CONSERVATION TEAM CONSULTATION APPLICATION RESPONSE

APPLICATION REF:	25/01534/FPH & 25/01535/LBC
CASE OFFICER:	VW
APPLICATION SITE:	3 Church Lane, Barkway, Royston, Hertfordshire, SG8 8EJ
DESCRIPTION OF WORKS:	Re-position front entrance door, replace existing rear door, replace existing windows and re-clad and paint exterior cladding. Internal alterations.

- **71/03063/1** - *Conversion of forge to dwellinghouse.*

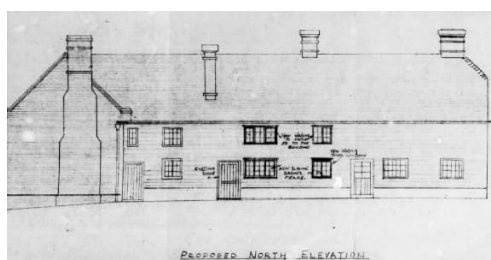
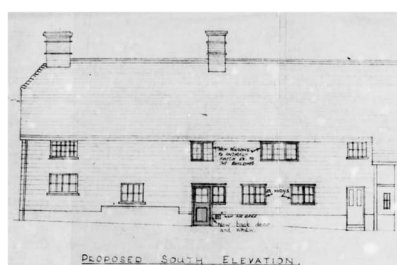
NB: Although originally approved on 23 November 1971 amended elevations are date-stamped 3 December 1971.
